HISTORIC AND DESIGN REVIEW COMMISSION

HDRC CASE NO: 2019-283
ADDRESS: 138 S JOSEPHINE TOBIN
LEGAL DESCRIPTION: NCB 2027 BLK LOT A1
ZONING: R-6,H
CITY COUNCIL DIST.: 1
DISTRICT: Woodlawn Lake and Park Historic District
APPLICANT: Melissa Douglas/Douglas Architects, Inc.
OWNER: Cathleen Crabb/CITY OF SAN ANTONIO
TYPE OF WORK: Final approval the new construction of a community center
APPLICATION RECEIVED: October 18, 2019
60-DAY REVIEW: December 17, 2019
CASE MANAGER: Stephanie Phillips
REQUEST:

COSA Woodlawn Lake Recreation Center

APPLICATION FOR FINAL APPROVAL

Salvage Plan

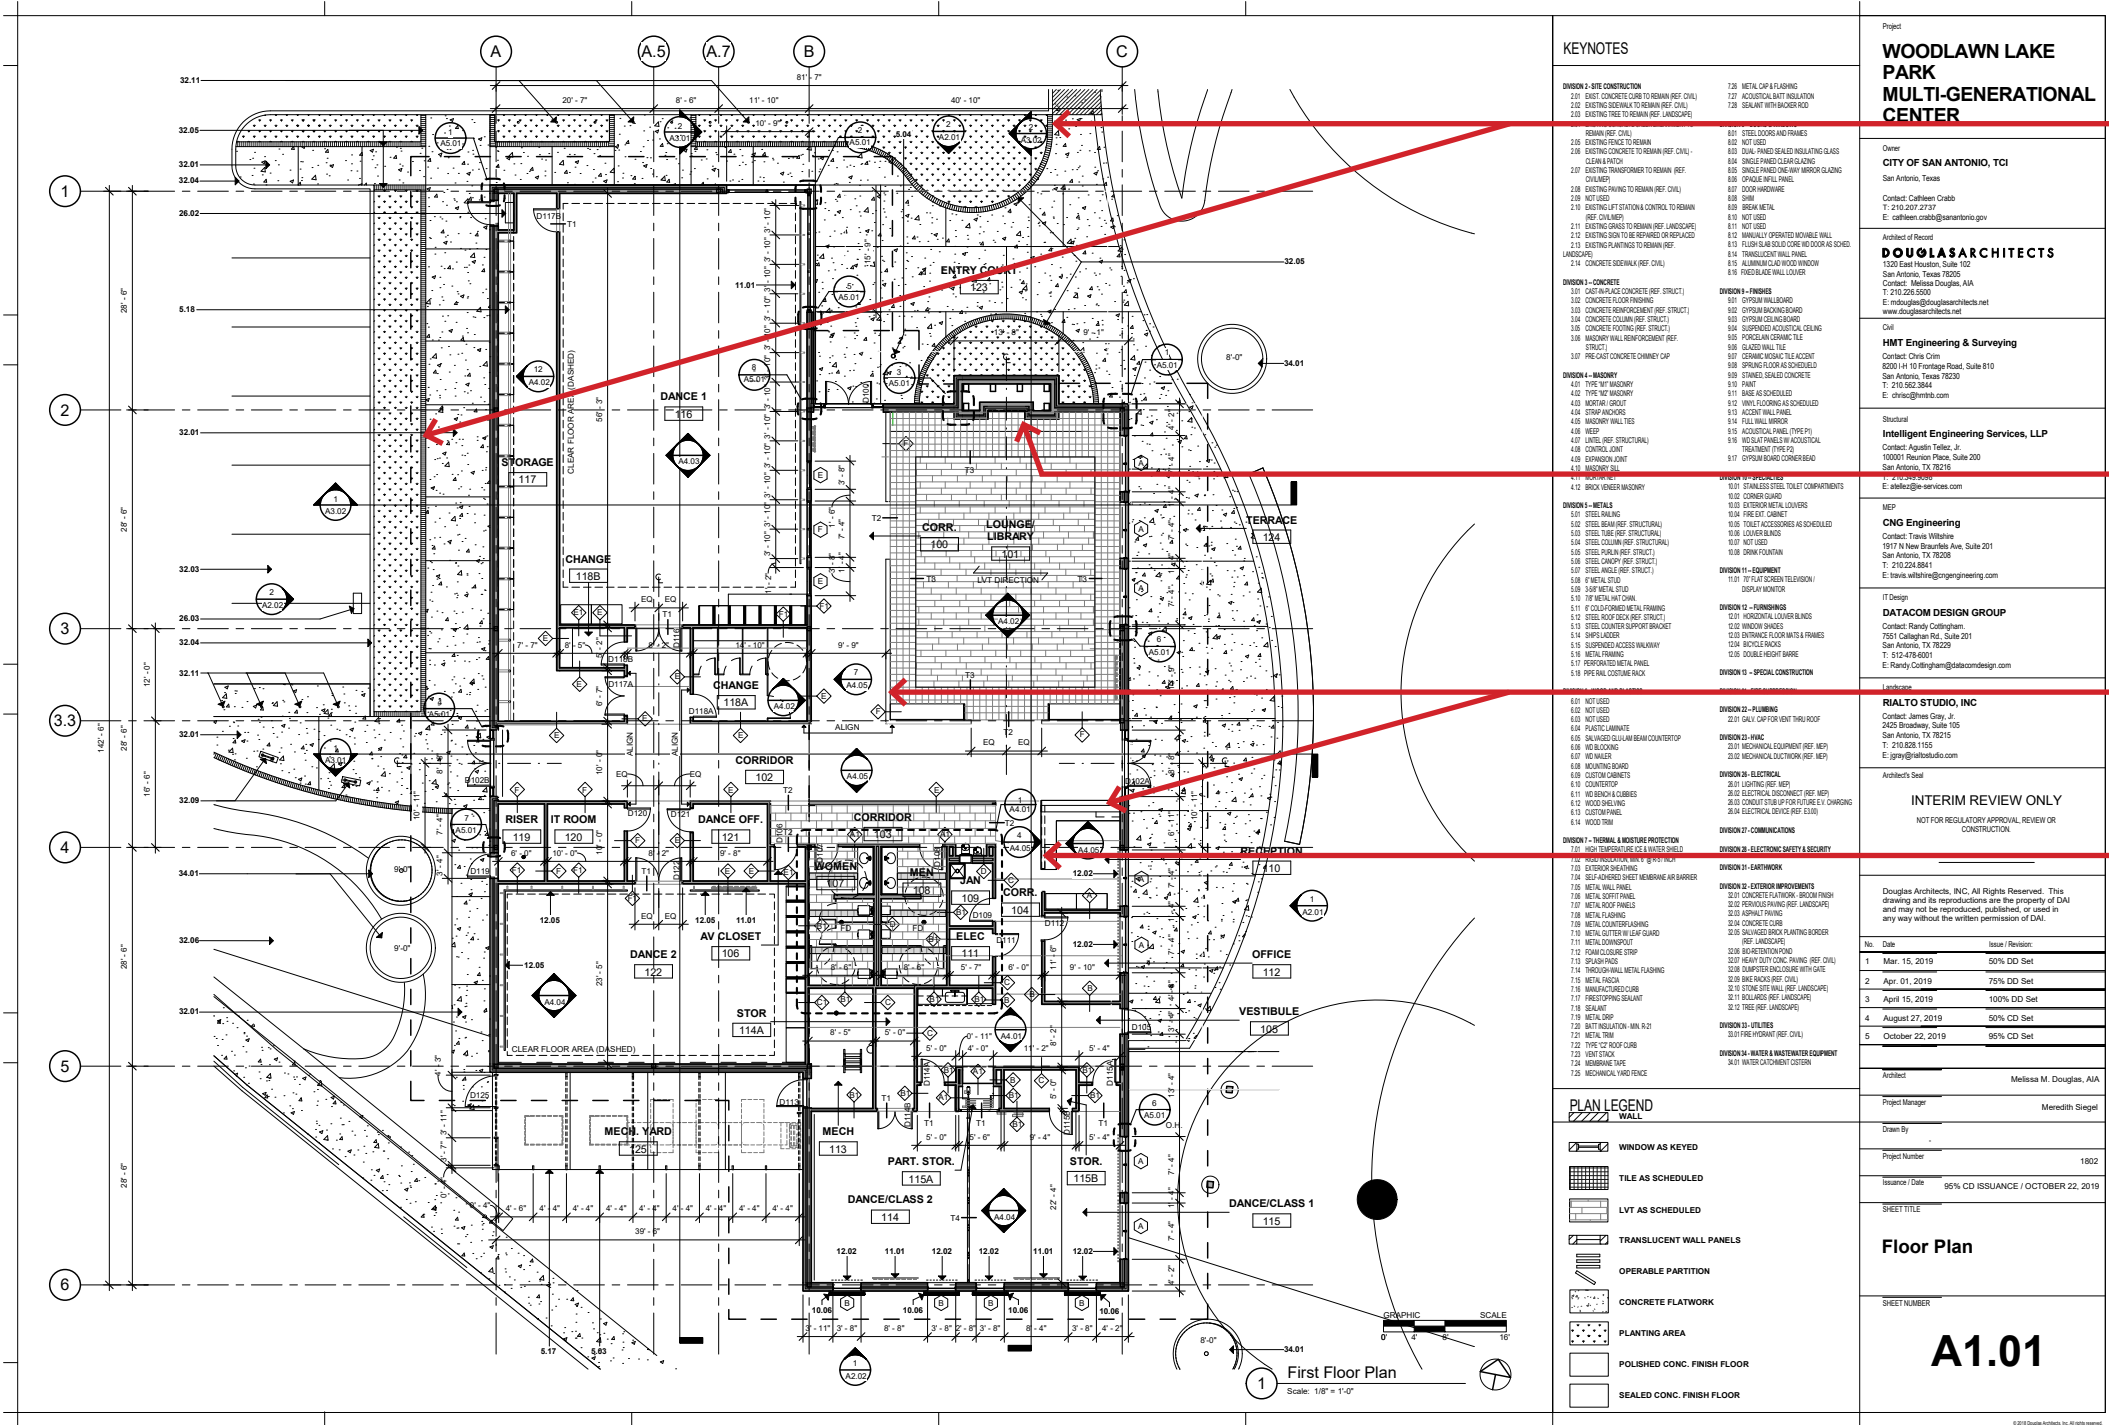
1. That the applicant provides a comprehensive salvage plan for the existing materials and reuses as much material as possible in the new structure, particularly the façade bricks, chimney bricks, and structural beams. Plans for material reuse within the new structure should be clearly illustrated in the submittal for final approval; **this stipulation has been met.**

Salvaged bricks to be re-used as paving and planting retainers.

Salvaged glulam beam to be re-used as mantelpiece.

Salvaged glulam beams to be re-used as millwork surfaces.

Salvaged ceiling boards to be re-used as millwork surfaces.

Increased Landscaping - Proposed Tree Preservation Plan

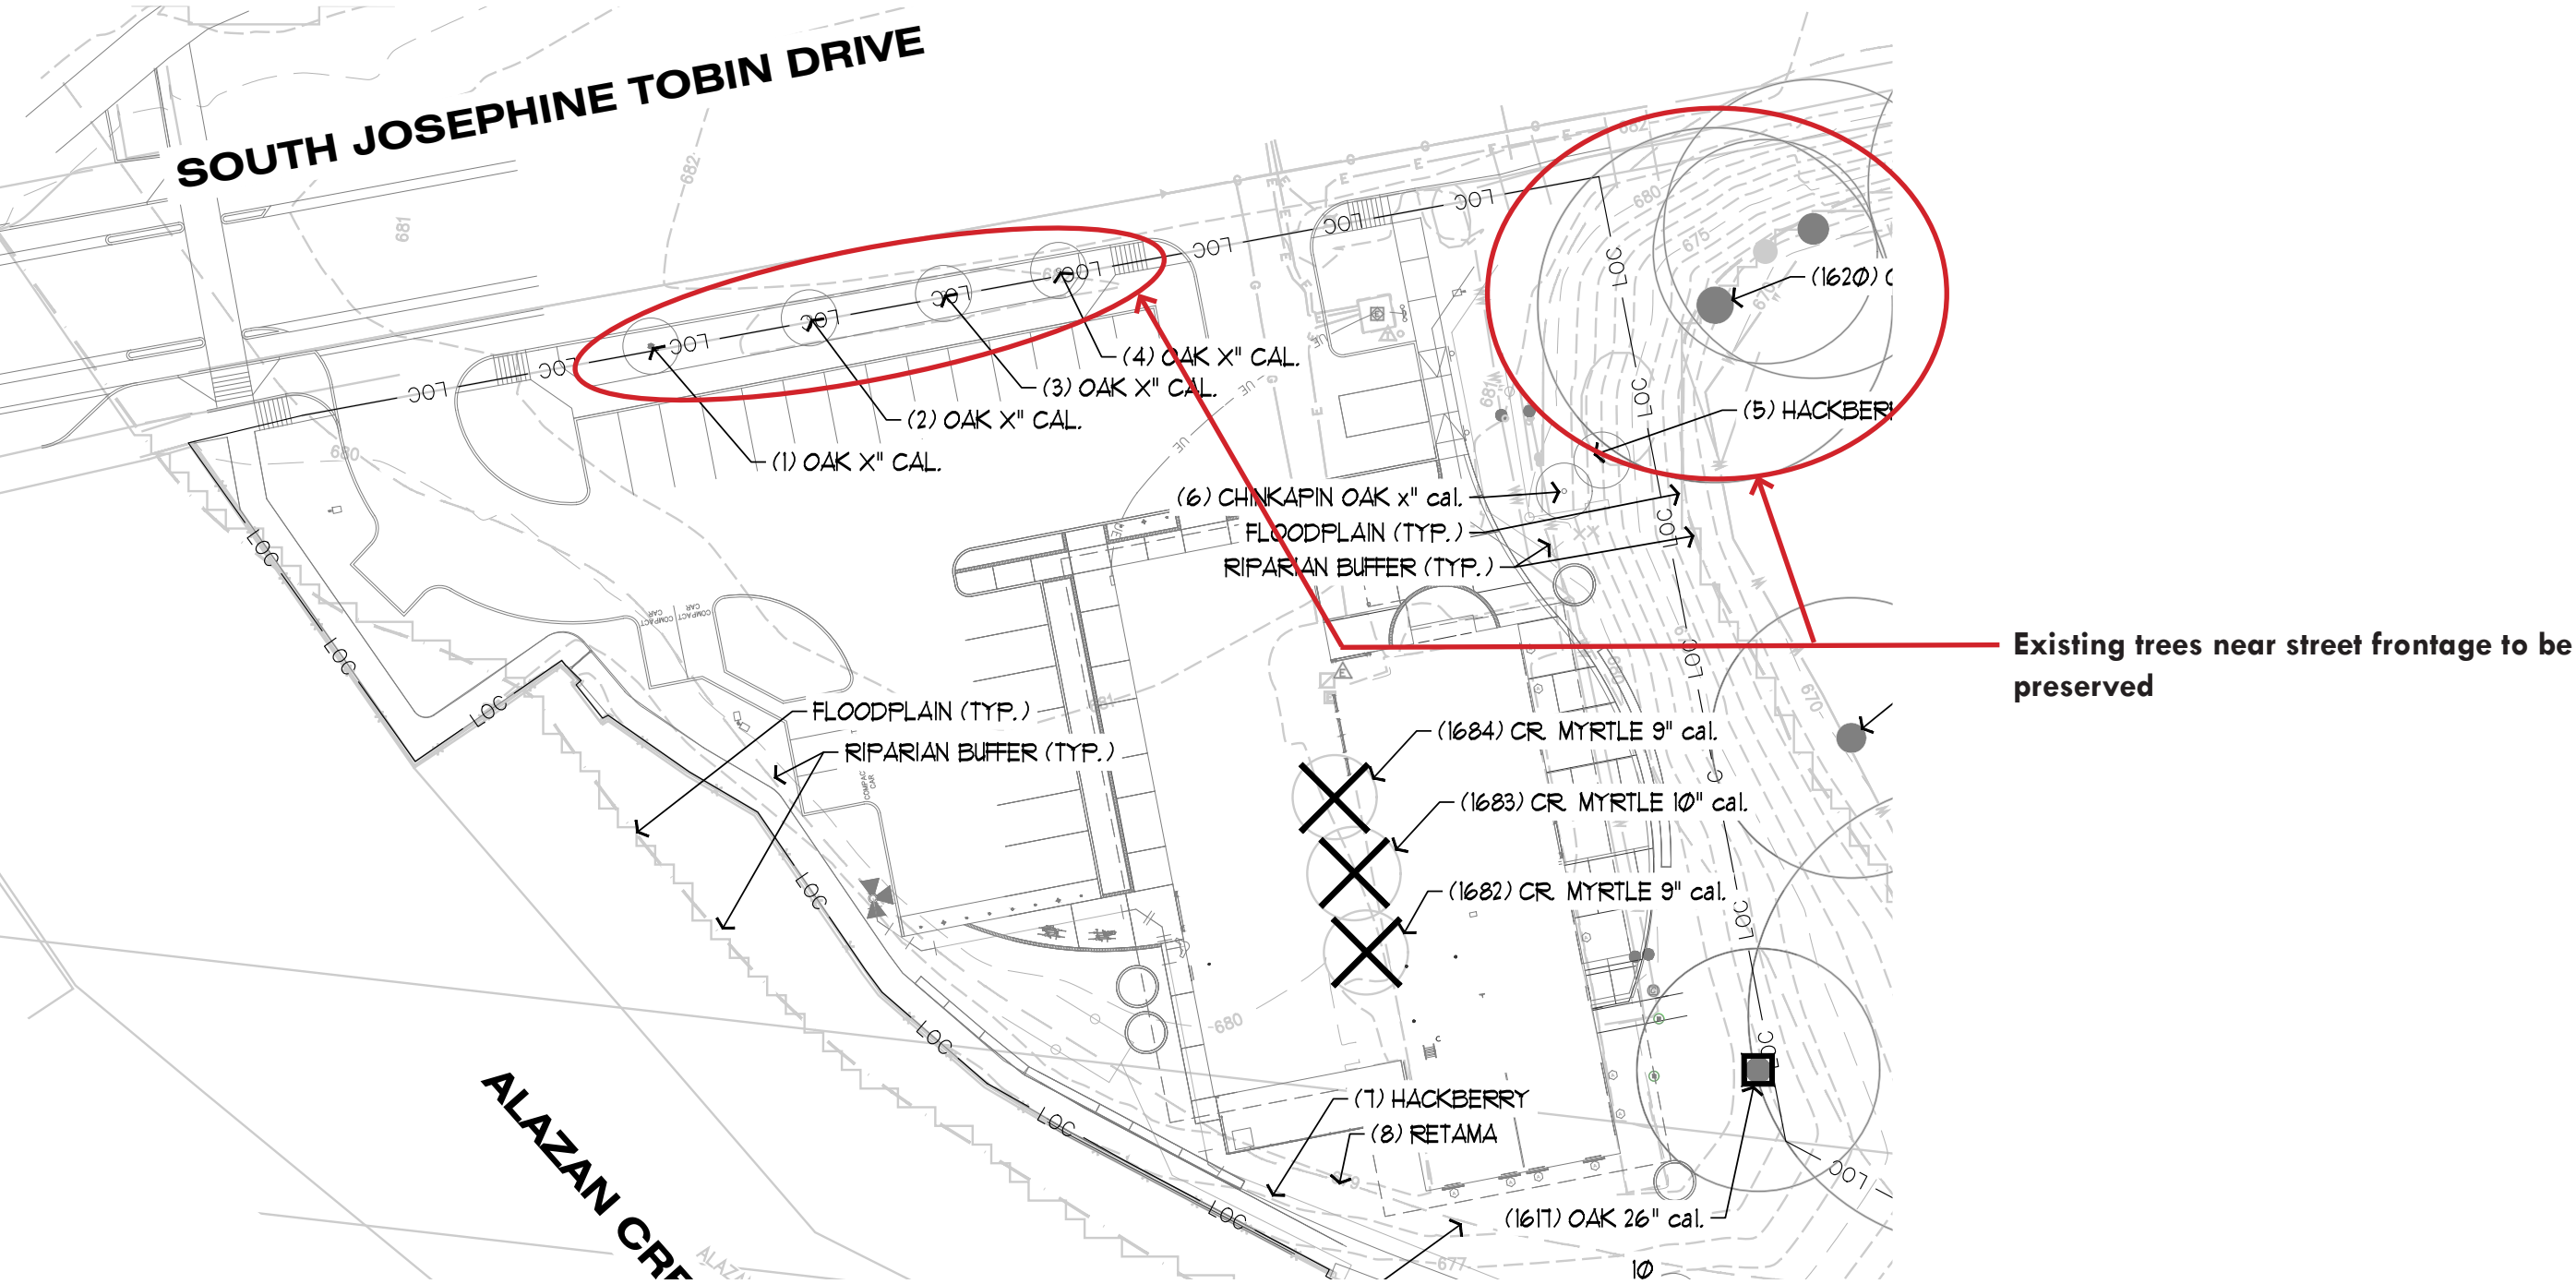
2. That the landscaping along the street frontage is significantly increased and that additional parking lot trees and shrubbery be introduced; **this stipulation has been met.**
